SACRAMENTO MUNICIPAL UTILITY DISTRICT □ 6201 S Street, Box 15830, Sacramento, California 95813; (916) 452-3211

Docket No. 50-312
Rancho Seco Nuclear Generating
Station, Unit 1

Response to February 26, 1980, NRC Requirements for the Continued Upgrade of the Rancho Seco Auxiliary Feedwater (AFW) System

FIGURE A.3-1

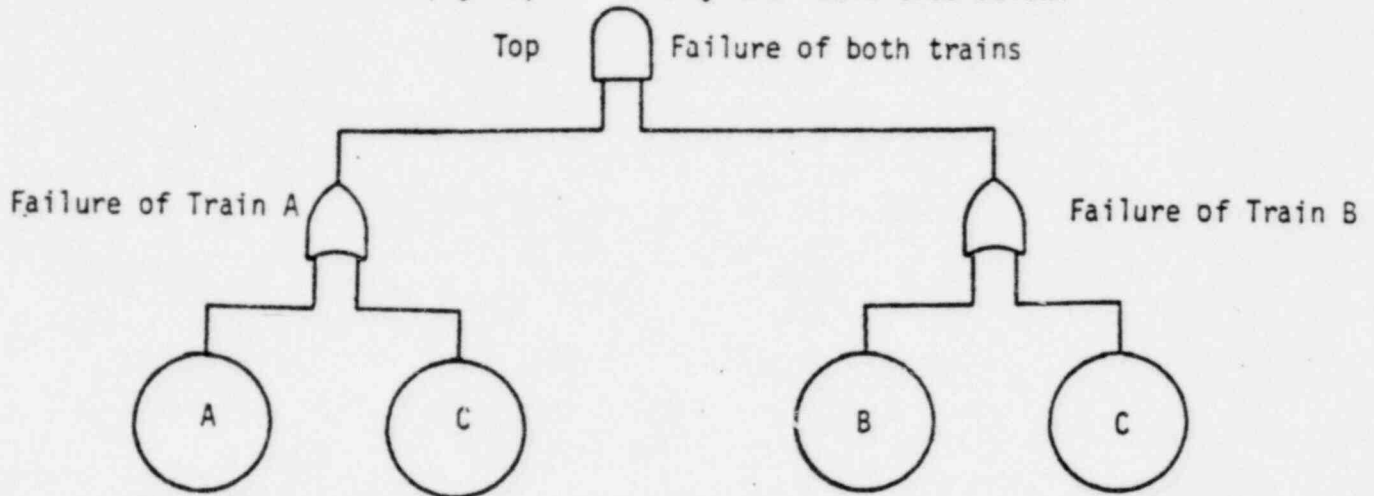
There is no discrepancy between the assumption of the ICS as a single control device and the fault tree shown on Pages A-7 and A-8. While ICS failure is shown on separate branches of the fault tree, this was done only to illustrate that ICS failure has a direct effect on the operation of control valves in both trains. The equivalency of the SMUD fault tree to a tree emphasizing the ICS commonality is shown in Figures A.3-1 and A.3-2.

In the Auxiliary Feedwater Reliability Analysis for the Rancho Seco Nuclear Generating Station, ICS failures are shown on separate branches of the fault tree. This can be simply represented by the fault tree below:

The probability of the top event in this tree is $P\{(AUC) \cap (BUC)\} =$

$$\begin{aligned}
 &= P(AUC) + P(BUC) - P((AUC) \cup (BUC)) \\
 &= P(AUC) + P(BUC) - P(AUBUC) \\
 &= (P(A) + P(C) - P(AC)) + (P(B) + P(C) - P(BC)) \\
 &\quad - \{P(A) + P(B) + P(C) - P(AB) - P(AC) - P(BC) + P(ABC)\} \\
 &= P(AB) + P(C) - P(ABC)
 \end{aligned}$$

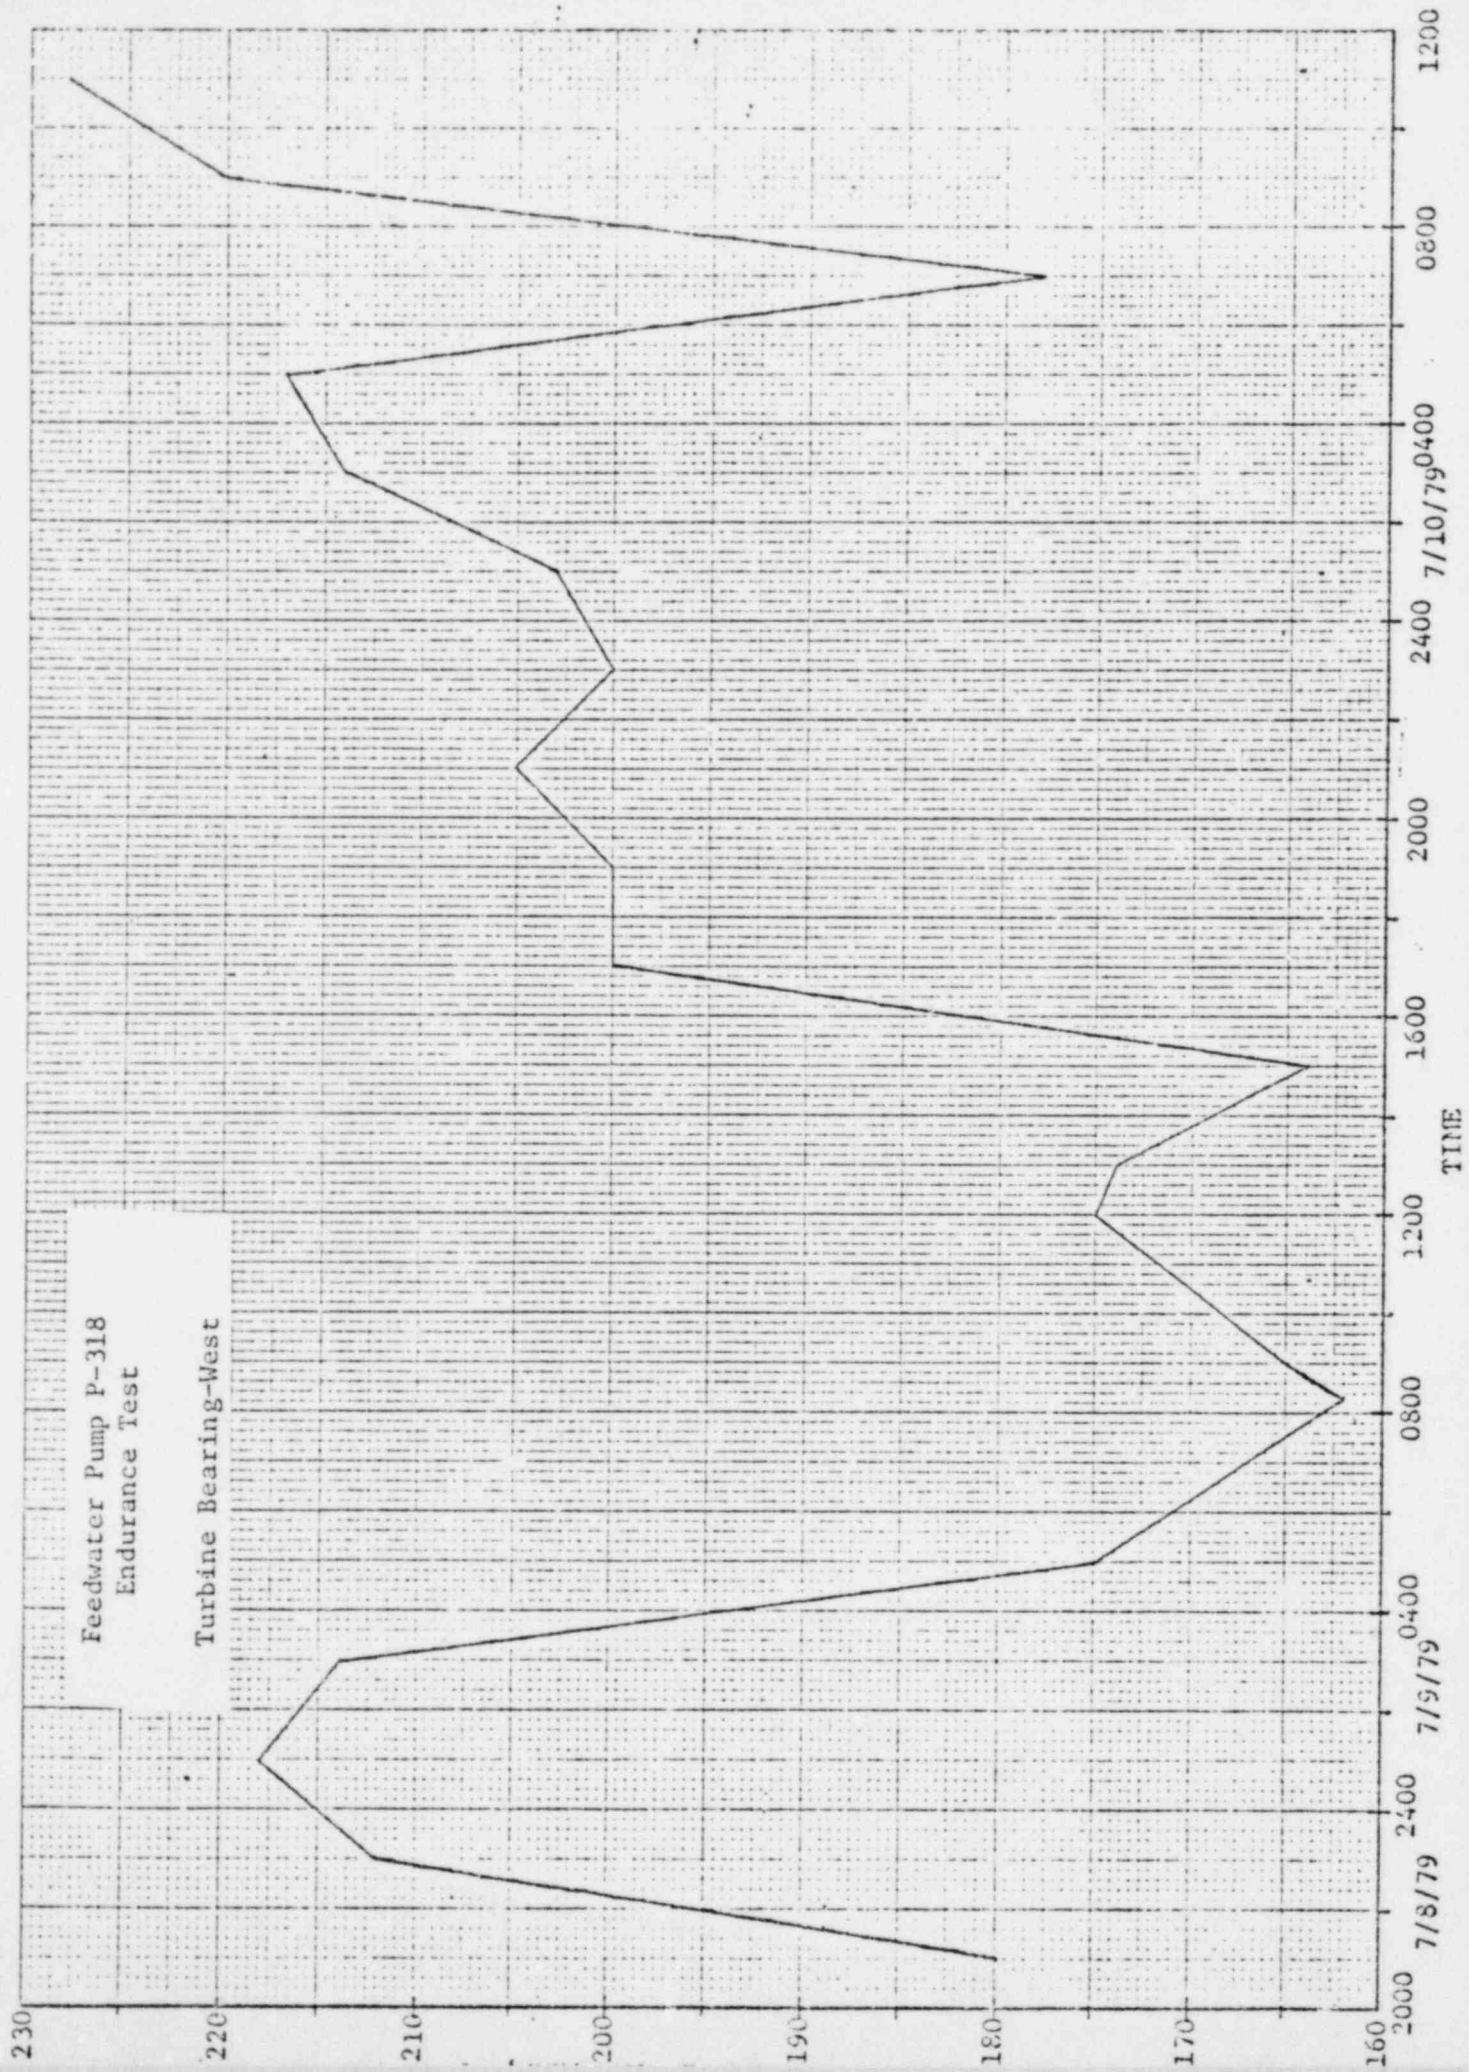
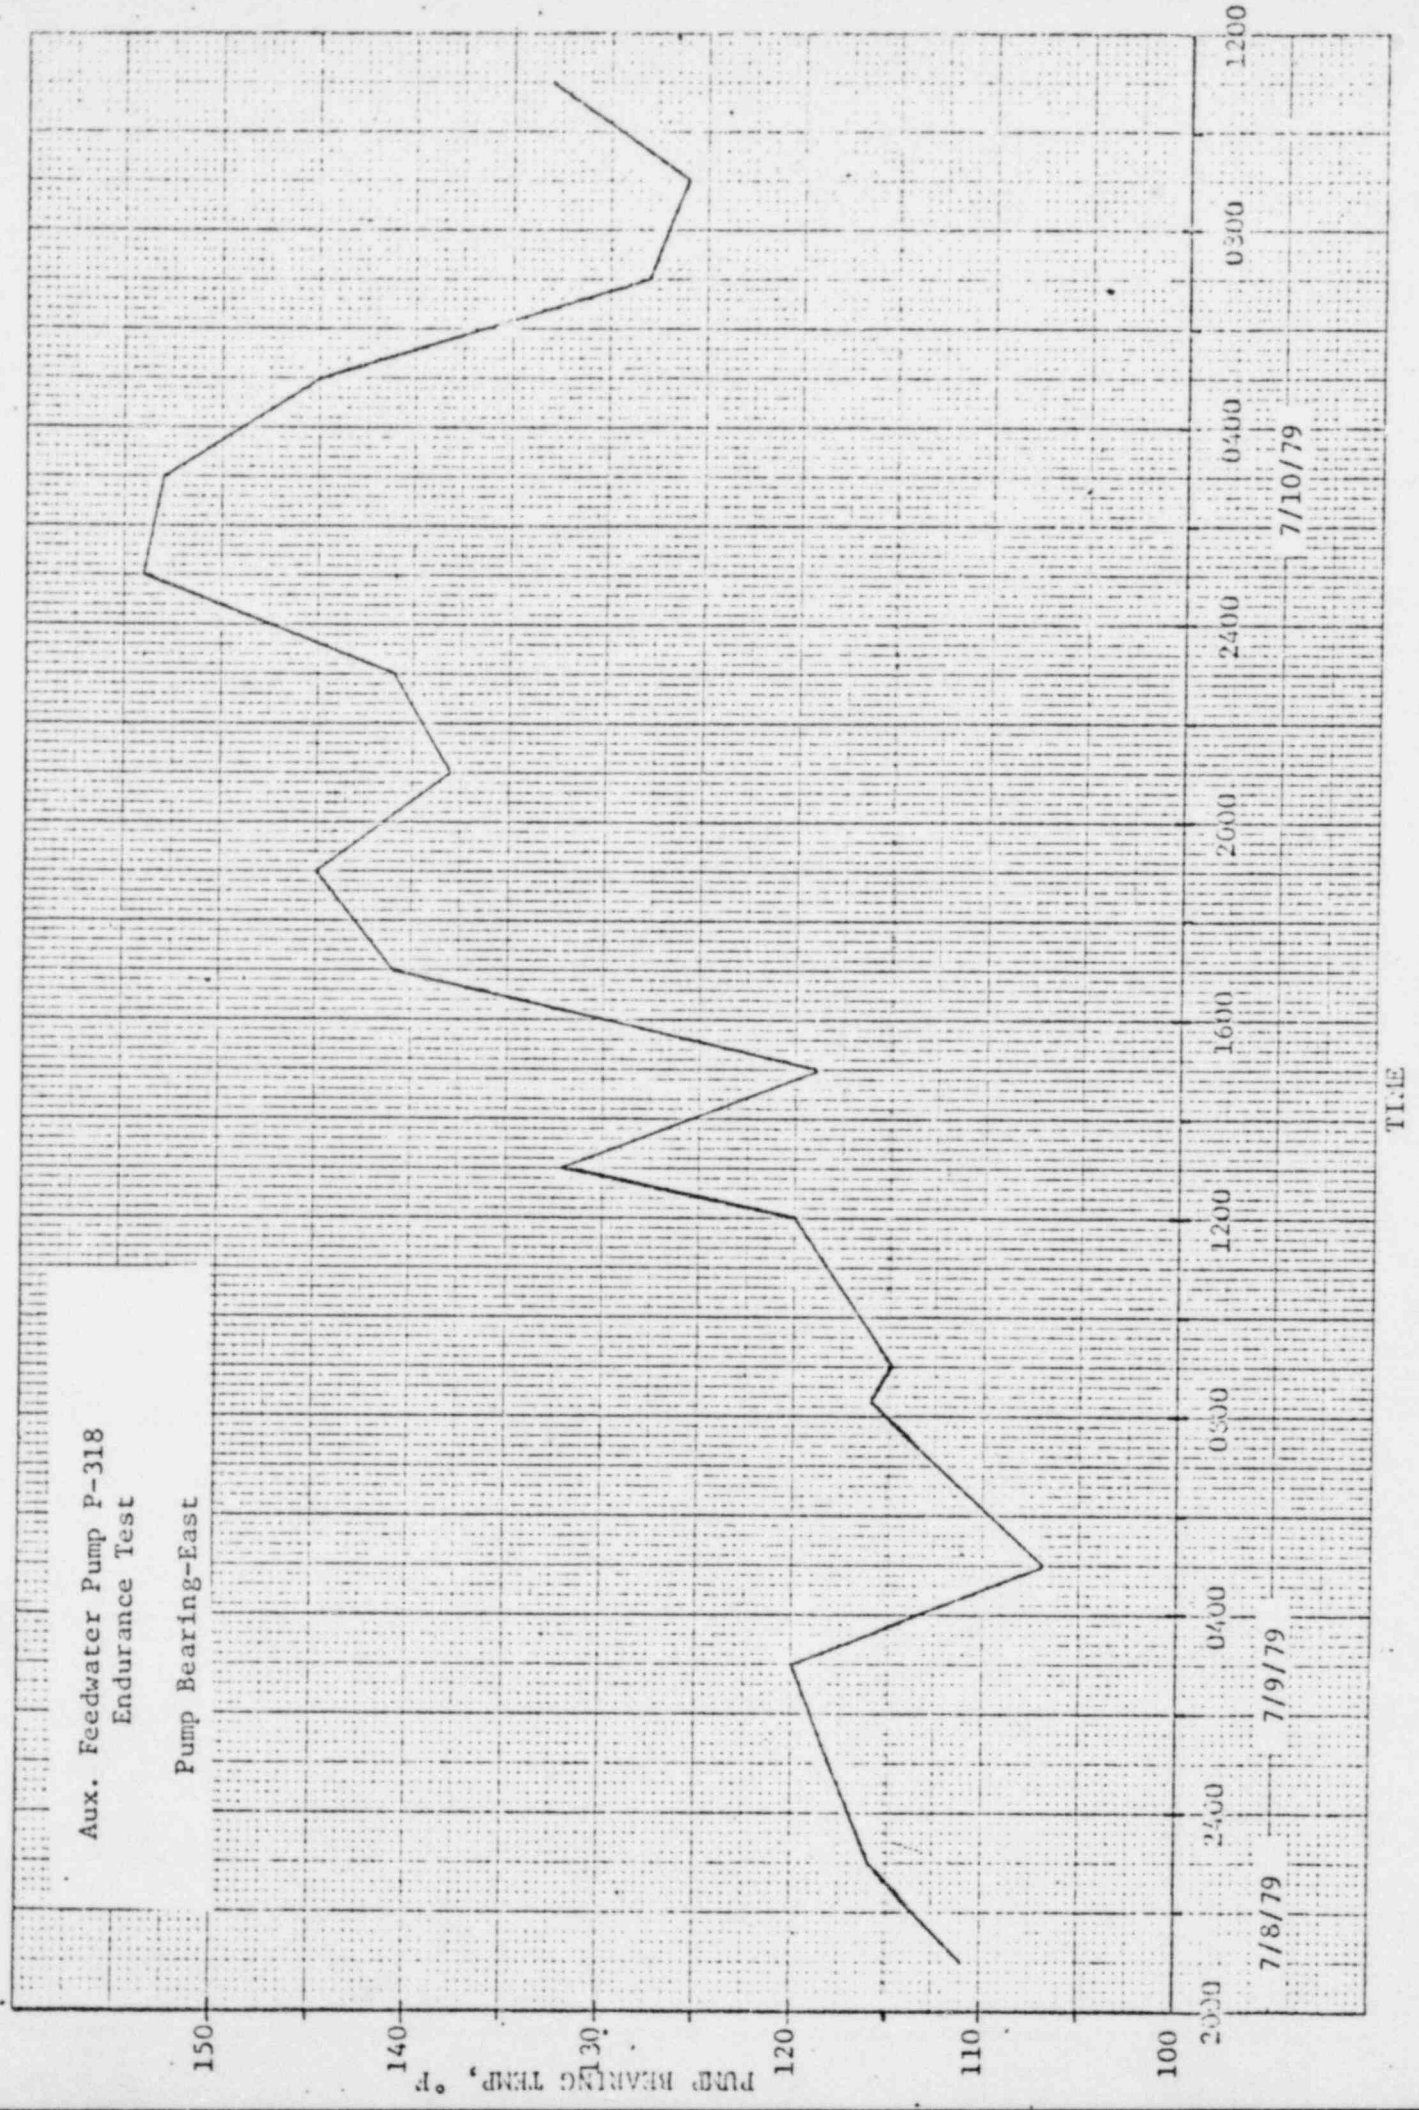
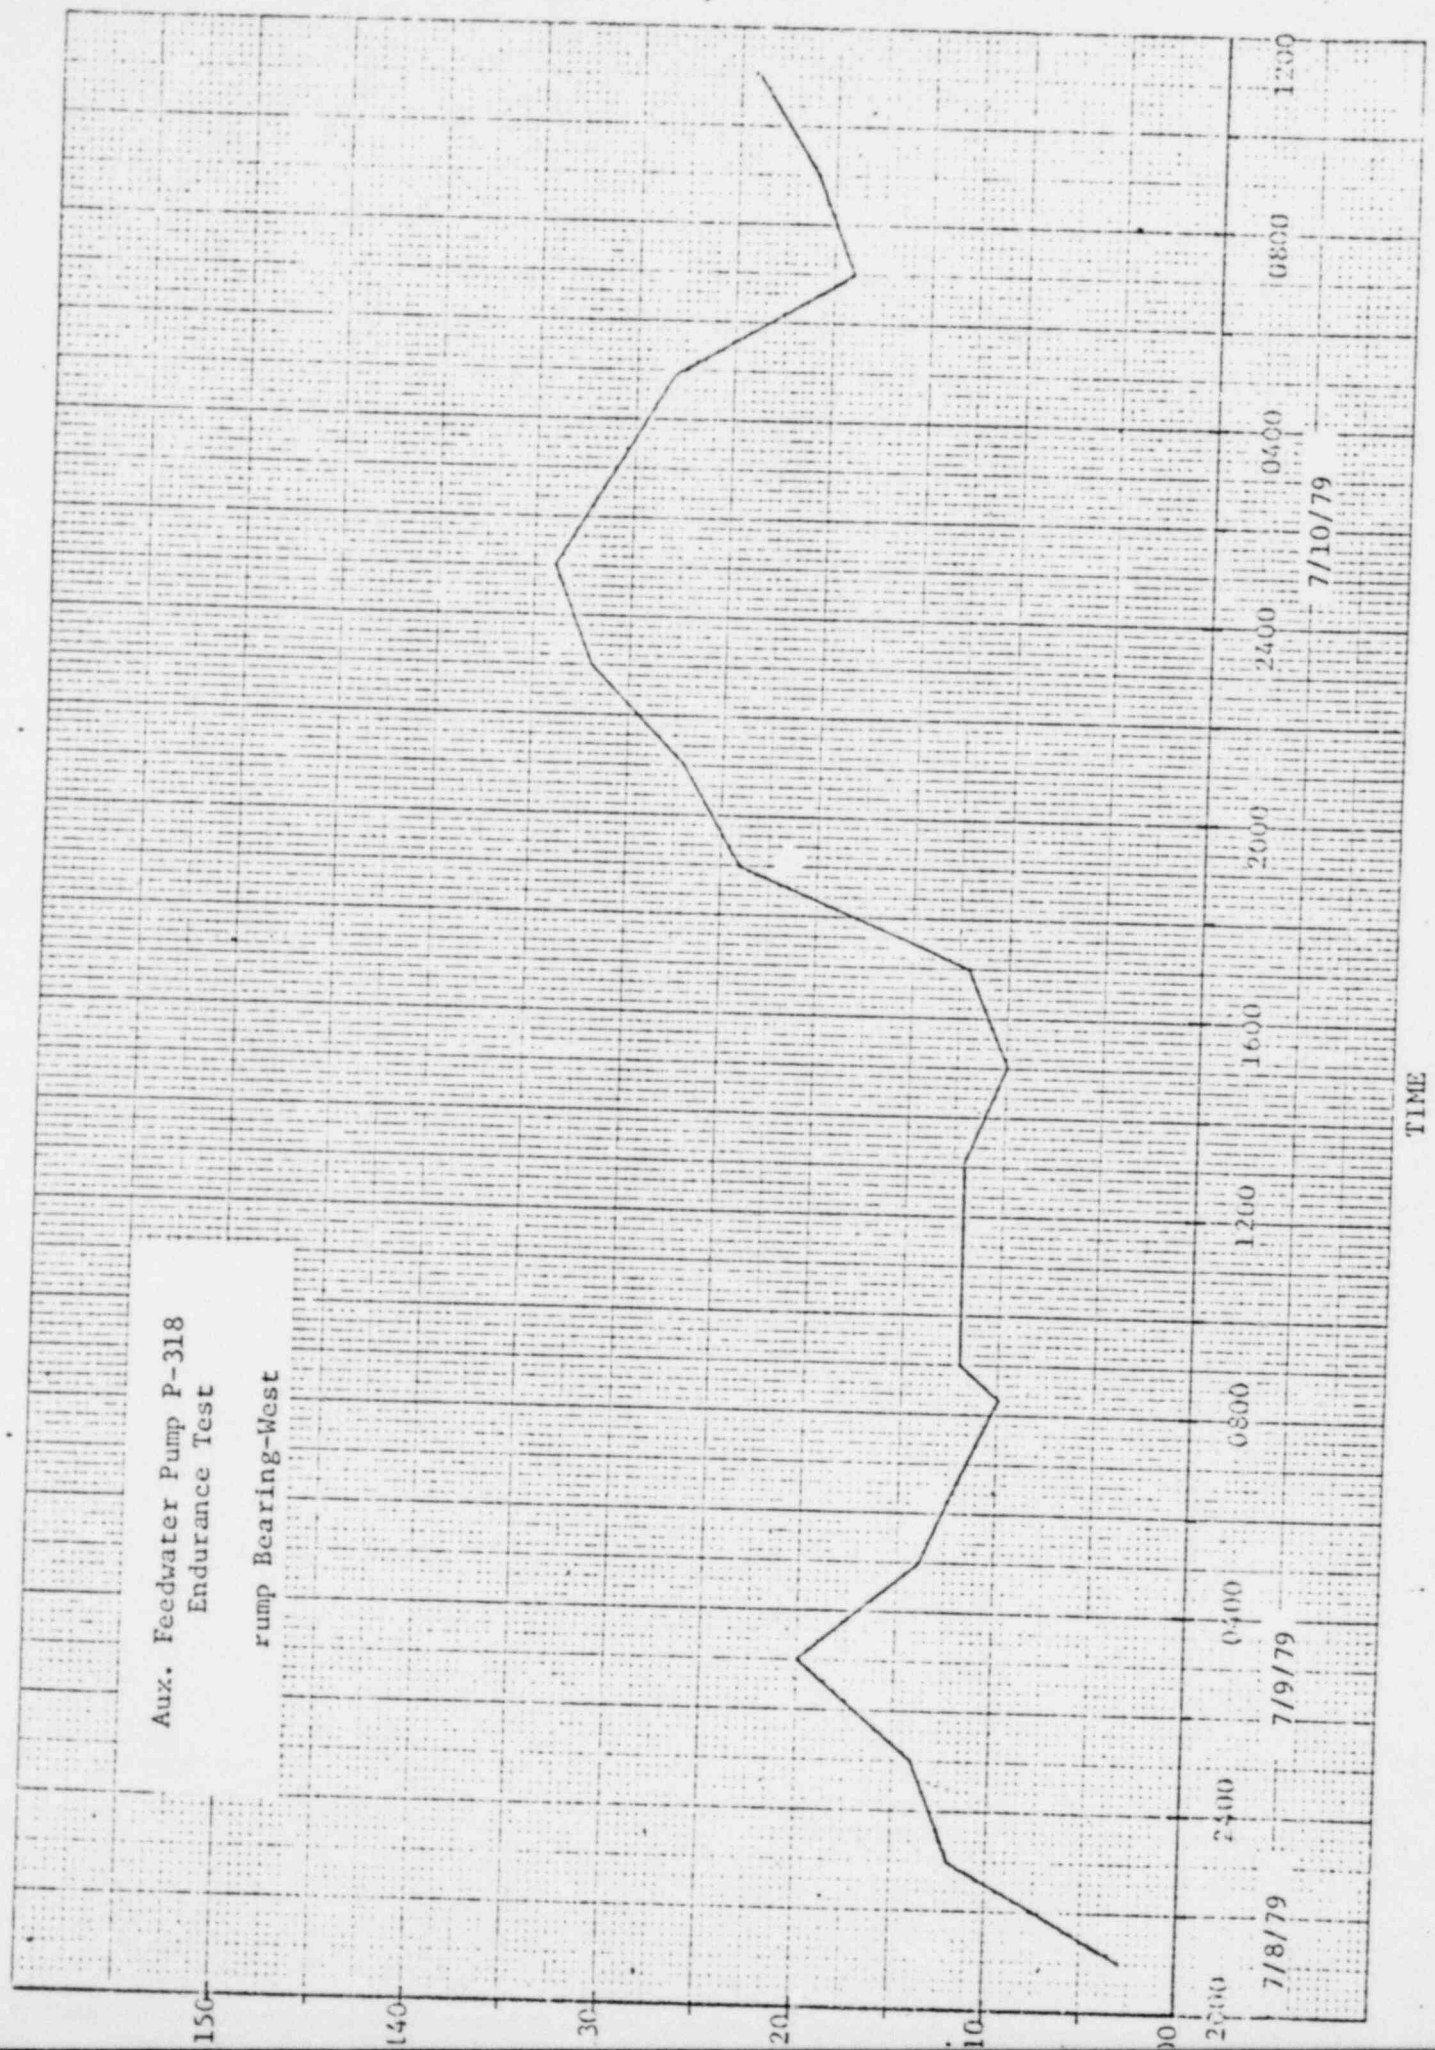
Plots of bearing temperature versus time are shown in Figures B.7-3 through B.7-10. At no time did the measured bearing temperatures exceed the manufacturer's rated maximum of 240°F. During the Full Flow portion of the test, bearing temperature increased due to the following three factors:

1. Condensate Storage Tank temperature increased from its initial value of 60-70°F up to approximately the temperature of the condenser hotwell due to make-up. Since the pumps and turbine use water extracted from the first pump stage for bearing oil cooling, any increase in pump suction temperature would be reflected in higher bearing temperatures.
2. Ambient temperature at the Site varied from 58°F at 0300 on July 7, 1979 to 72°F at 1100.
3. Increasing gland seal leakage from the turbine driver caused the measured bearing temperature at the West (governor end) Turbine Bearing to increase at the end of the test of P-318. This measured temperature is higher than the bearing temperature

due to heating of the pyrometer probe by leaking steam. This steam leakage, while not excessive, tends to raise the measured bearing temperature when a contact pyrometer is used.

The turbine bearing temperature data for Pump P-318 was rather erratic. This is most probably due to poor technique in obtaining the data. Since it cannot be conclusively shown that the bearing temperatures stabilized at an acceptable value during the test, this pump will be retested using the turbine driver. The turbine will be tested with the pump at full flow for a minimum of eight hours and data will be taken hourly. If the turbine bearing temperatures have not stabilized at the end of eight hours, the test will be continued until each turbine bearing temperature has been stable for at least four hours. A temperature will be assumed to be stable if in a four hour period the temperature does not vary more than 20°F and the final temperature is not more than 50°F higher than the temperature at the previous hour's data point. This test will be performed during power operation following the refueling maintenance outage currently in progress.
